## HISTORIC AND DESIGN REVIEW COMMISSION

**HDRC CASE NO:** 2018-612  
**ADDRESS:** 126 VILLITA ST  
112 VILLITA ST  
**LEGAL DESCRIPTION:** NCB 986 BLK LOT 24A & NW TRI PT & NE TRI 24.68 FT OF 25  
**ZONING:** D, RIO-3  
**CITY COUNCIL DIST.:** 1  
**APPLICANT:** Miguel Saldana/B&A Architects  
**OWNER:** Tim Barton/Villita Towers LLC  
**TYPE OF WORK:** Construction of a twenty-four story residential structure with a detached parking structure  
**APPLICATION RECEIVED:** November 30, 2018  
**60-DAY REVIEW:** January 29, 2018  
**REQUEST:**

The applicant is requesting conceptual approval to:

1. Construct a twenty-four (24) story, multi-family residential structure with mixed-use at the street level on the vacant lot at 112 Villita Street.
2. Construct a parking structure on the lot at 126 Villita Street. This would require the demolition of an existing building on the site that has been determined eligible for historic designation by OHP staff.

2 SOUTH ELEVATION

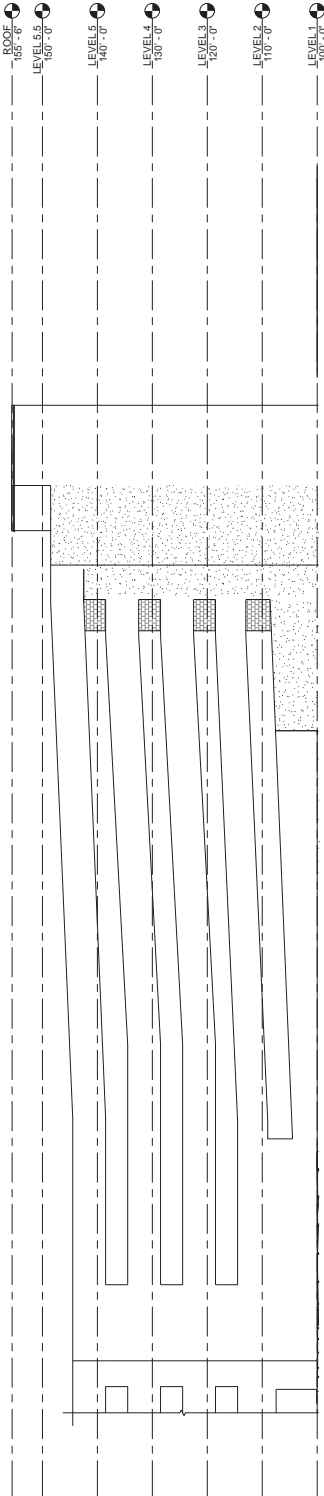
- 1n. **FAÇADE COMPOSITION** – The applicant has proposed for the south elevation to feature relatively no separation, fenestration or detailing. A panel system will compose the majority of this elevation. The UDC Section 35-672(b)(4) notes that where building facades face a street or river, the maximum length of a wall plane cannot exceed thirty (30) feet. Where this occurs, a change in material, change in height, change in roof form or a change in fenestration must occur. The proposed south elevation is not consistent with the UDC.
